An outsider's view of HS2 airborne noise

Peter Delow

Blogging on *HS2 and the environment*

WHAT IS THE HS2 LTD VIEW?

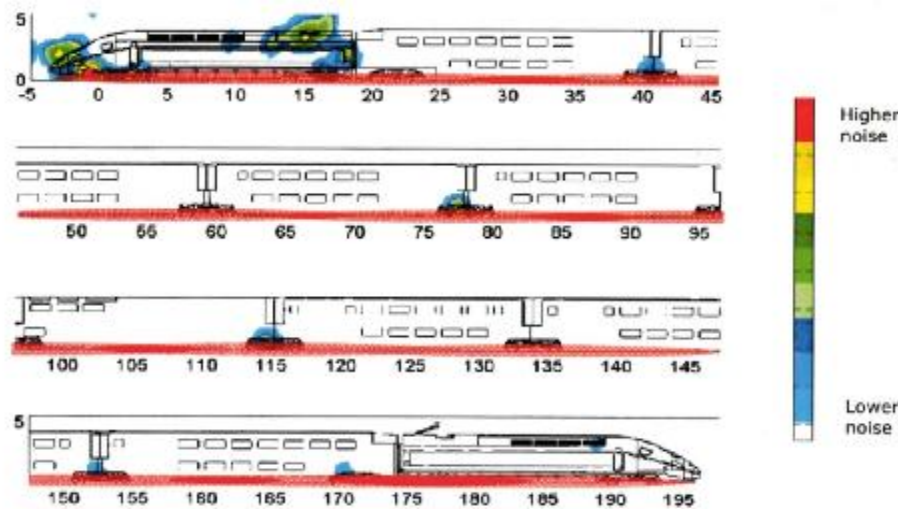
Fears are due to “misunderstandings” – HS2 Ltd presentation, September 2012

“While noise from the pantograph does need to be considered, and will be reviewed at the time of the EIA, its significance is often overstated. The wheel-rail interface will remain the most significant part of the noise from the train, even at high speed.

WHAT IS THE LIKELY IMPACT OF PANTOGRAPH NOISE?

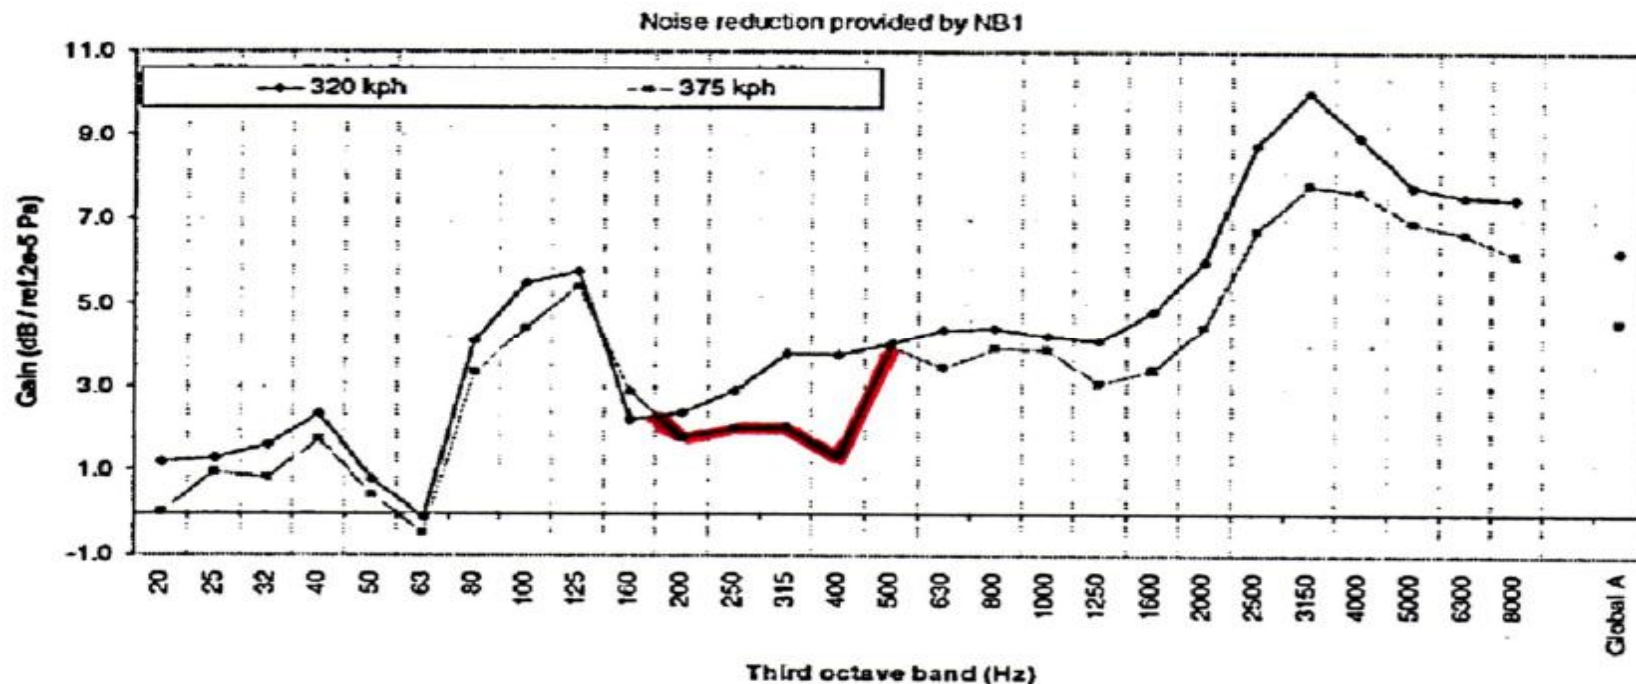
“... these solutions [improvements to noise barrier design] are limited at higher running speed when aerodynamic noise sources located on the roof of the train cannot be neglected.”

“At higher running speeds, the energy of aerodynamic noise sources located on the roof of the train increases and the barrier height is not sufficient.”

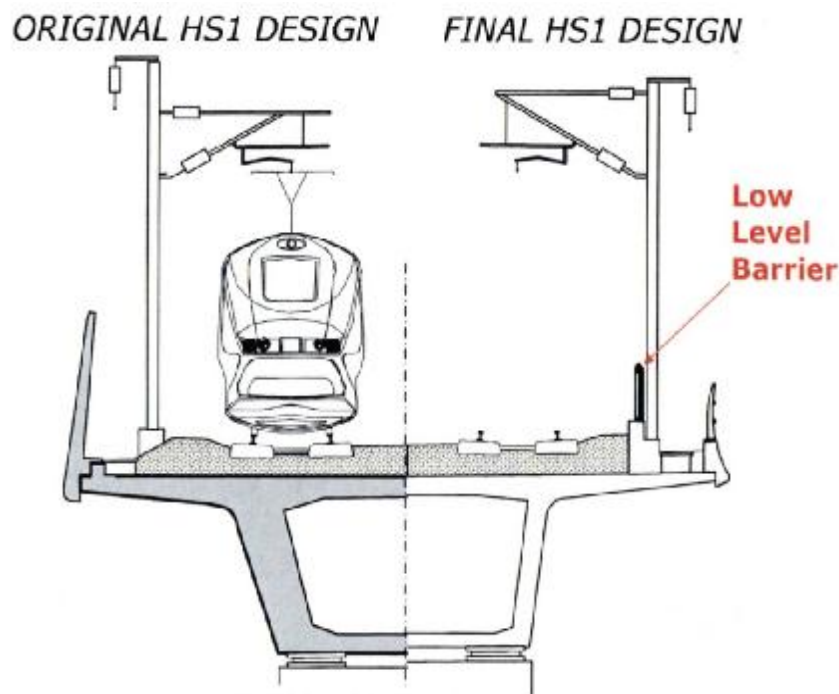
HS2 Ltd advises that the noise reduction of a 3 metre absorptive barrier is 10.1 dB (FOI11/327) – but this will not help with pantograph noise

Surely, it means higher barriers

Would this HS1 design shield the pantograph?
